Heather Godsmark

Swallowfield, Eastergate Lane, Eastergate, Chichester, West Sussex

## OBJECTION

I request that this statement be lodged as an object on the WSCC Planning Application Website against application WSCC/052/20.

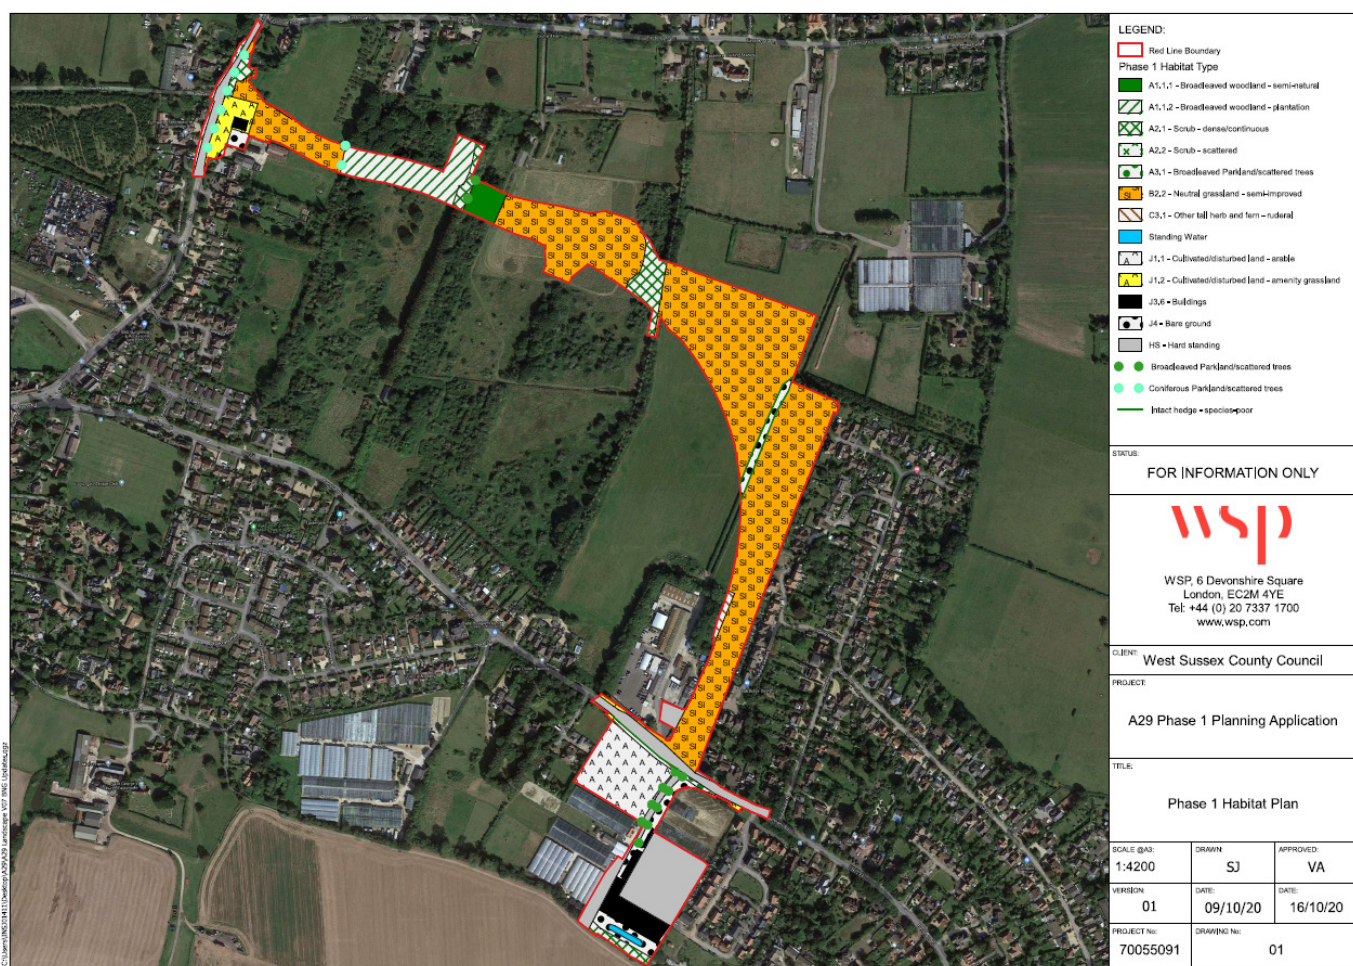
App 9.10 Bio Diversity Net Gain G Final Assessment evaluates the bio diversity losses and gains related to the new road development design and appraises the soundness of the design methodology and design elements.

Its Executive Summary confirms that *'the biodiversity value of existing habitats has been quantified using the: Natural England Biodiversity Metric 2.0, 2019 on the basis of comparing the identified existing habitats present on site (Appendix, Figure 1) and those proposed under the current design of the post-development landscape design (Appendix B, Figure 2)'*. I note that both habitat plans were issued 09/10/20, so quite close to application submission.

The above Semi-natural and Plantation Broadleaved Woodland patterns, existing habitat identities, (solid Green and Green horizontal stripes), are carried forward for use on the Post Development Plan, to identify proposed mitigation habitat types, taken from the application landscape drawings.

App 9.10 (Bio Diversity Net gain Assessment Final) stated that the Post-Development Habitat Plan was digitised from the WSP Soft Landscape Plan drawing no. A29-WSP-LAGA-001 - Version 7-06.10.20 (WSP, 2020) received on 05 October 2020.

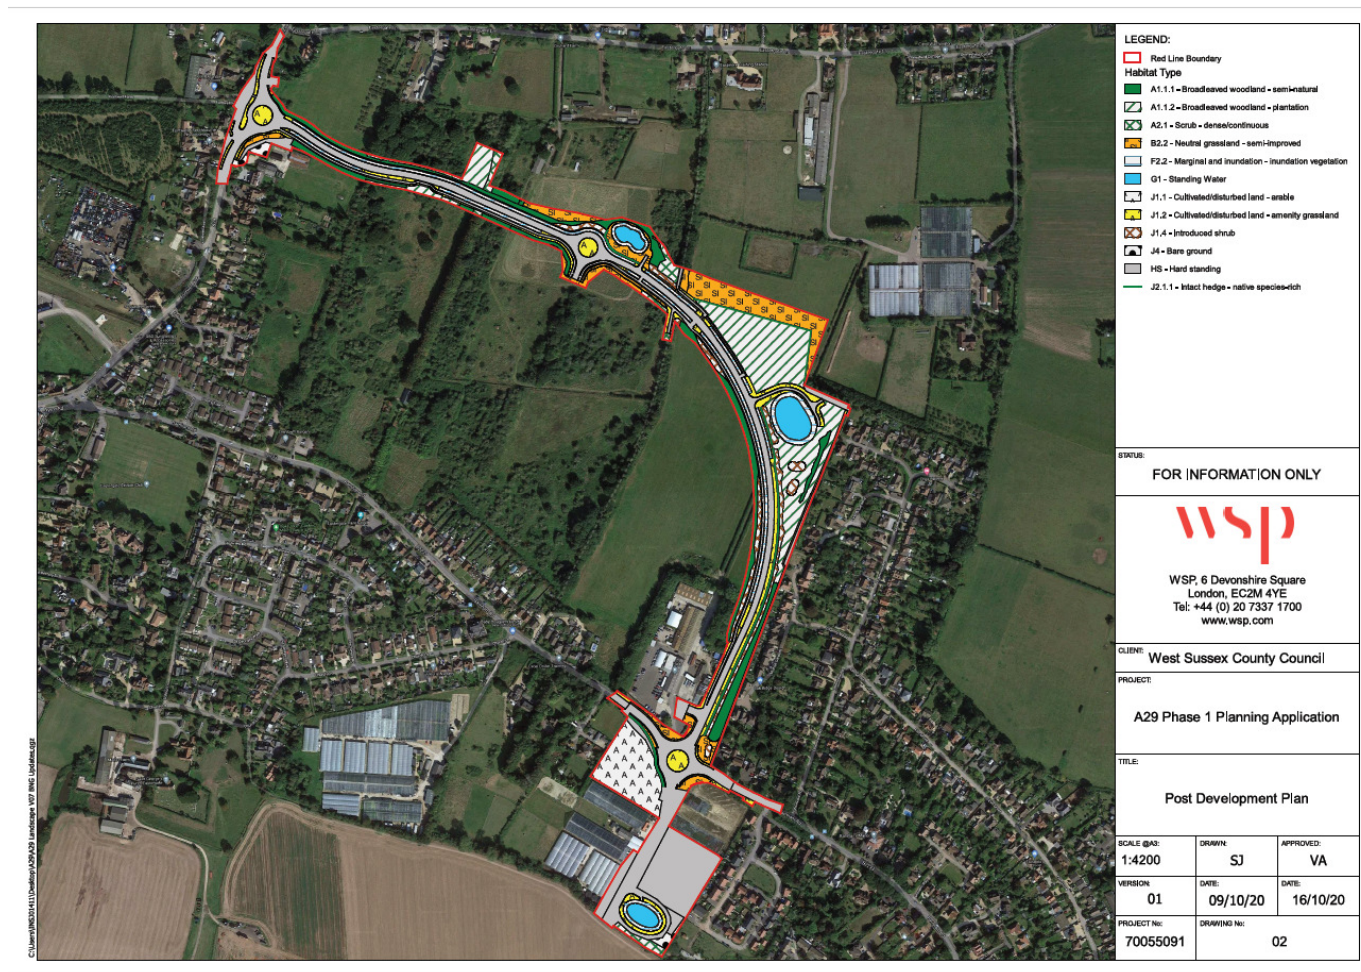
Comparison of the Post Development Habitat Plan against the Scheme Soft landscaping drawings and associated plant schedules, reveals substantial inconsistencies.

There is **woodland edge** planting indicated on Soft landscape drawings and in associated plant schedules, comprising smaller growing native trees and shrubs. However, there is **no woodland core in the soft landscape proposals**, though I note it remains identified in Drawing (pattern) Key. Additionally, provision of Woodland mitigation planting is variously mentioned throughout the application documents and identified on the Post Development Habitat Plan but there is no **woodland core mix** on scheme soft landscaping or in plant schedules.

**So there will be no mitigation woodland, as claimed variously throughout application texts, to replace that lost and to restore connectivity with adjacent woodland. There are no tall growing, native woodland, species, characteristic of this site's existing woodland surroundings, anywhere in planting proposals; no oaks or hornbeam.**

Showing the relationship between Chantry Mead Housing Development, its failed SuDs system location, its estate fence running east of Barnham Lane Ditch and the Raised A29 Realignment Road with Noise Barrier.

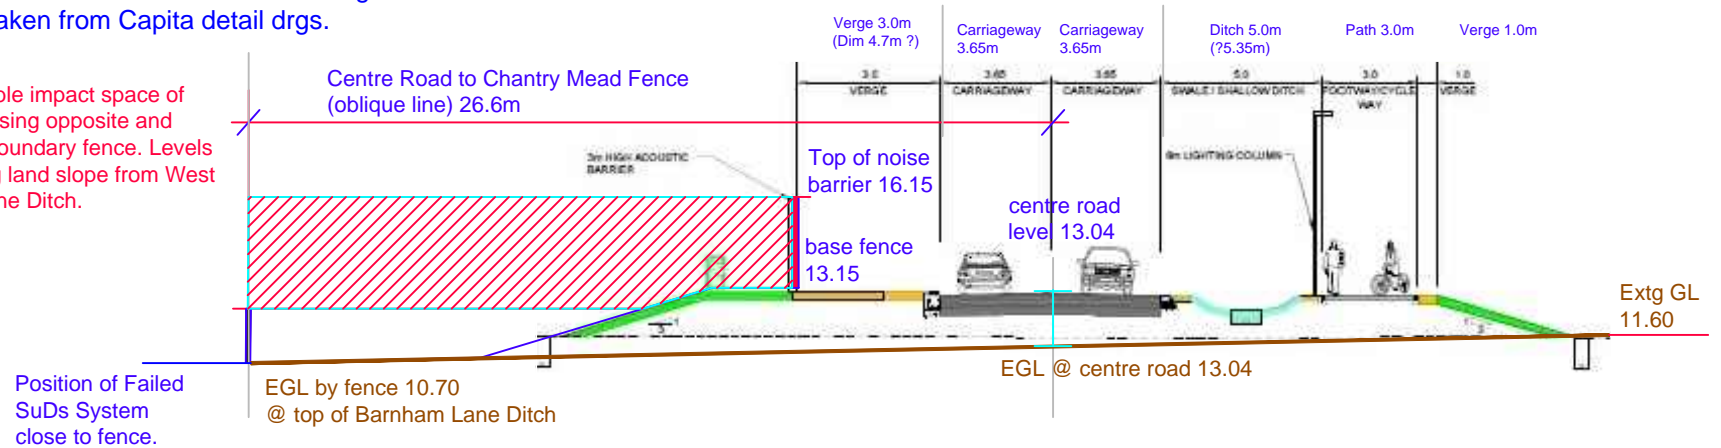
Noise Barrier occupies a visible impact space of minimum 3.65m towards housing opposite and pedestrians, looking above boundary fence. Levels take into account the existing land slope from West to East towards Barnham Lane Ditch.

### SECTION Y-Y @ CHAINAGE POINT 1020.00

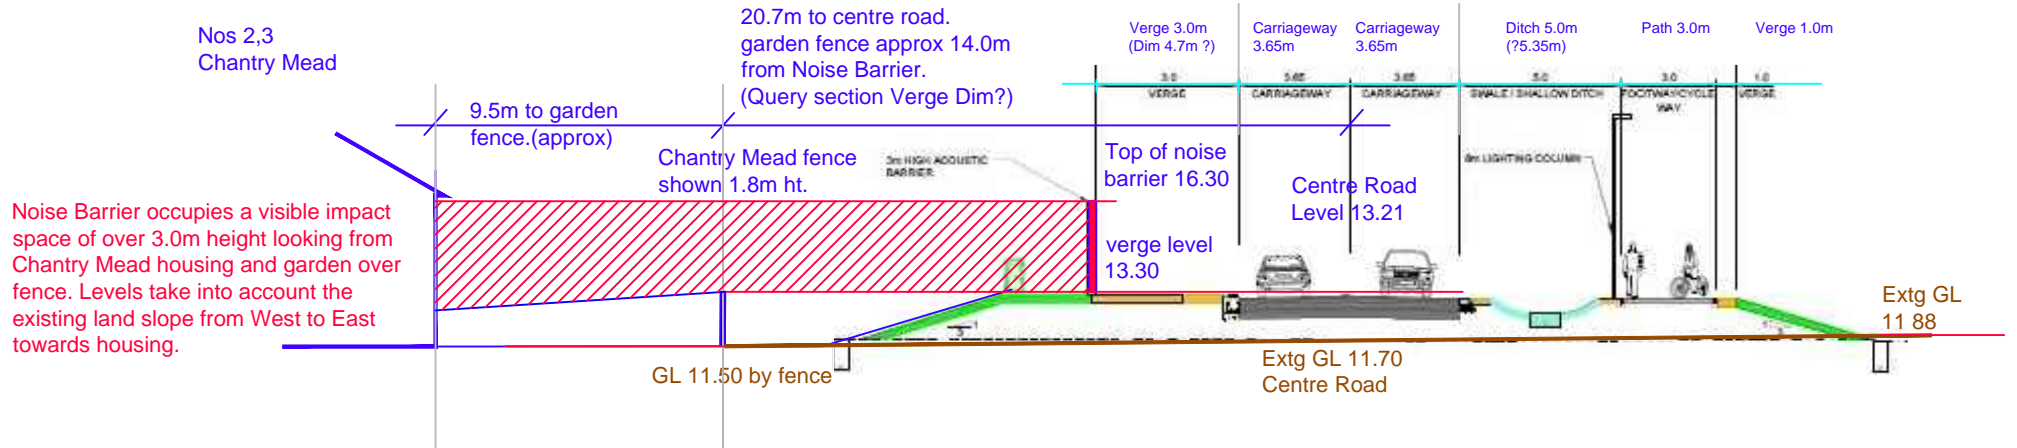
Noise Barrier occupies a visible impact space of over 3.0m height looking from Chantry Mead housing and garden over fence. Levels take into account the existing land slope from West to East towards housing.
